**INITIAL STATEMENT OF REASONS  
FOR PROPOSED BUILDING STANDARDS  
OF THE STATE FIRE MARSHAL  
REGARDING THE 2019 CALIFORNIA RESIDENTIAL CODE  
CALIFORNIA CODE OF REGULATIONS, TITLE 24, PART 2.5**

**([RULEMAKING FILE #])**

Example 1

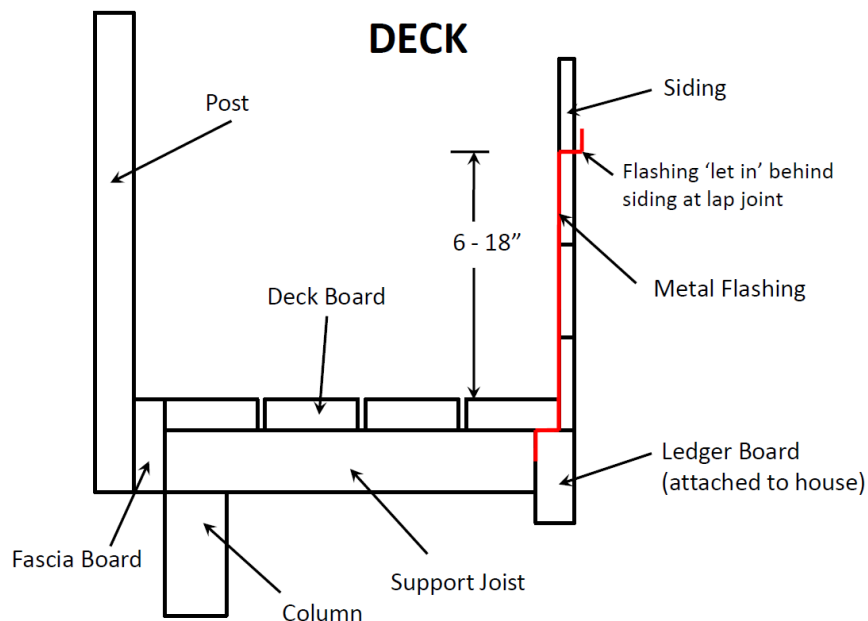
It has been shown that applying metal flashing to the intersection of the wall and the deck will protect the wall from flame spread along the deck, at a small additional cost.

Section 5.6.4 A minimum of 6 in. (150 mm) noncombustible vertical separation between a horizontal surface and siding shall be maintained.

The examples 1 and 2 are show for reference only on to how one may achieve compliance

with the code proposal. The code was written as a generic regulation to leave it up to the designer, architect or owner to create a desirable look to meet the intent, which is to prevent the accumulation of debris at the base of the intersection of the exterior wall and deck surface.
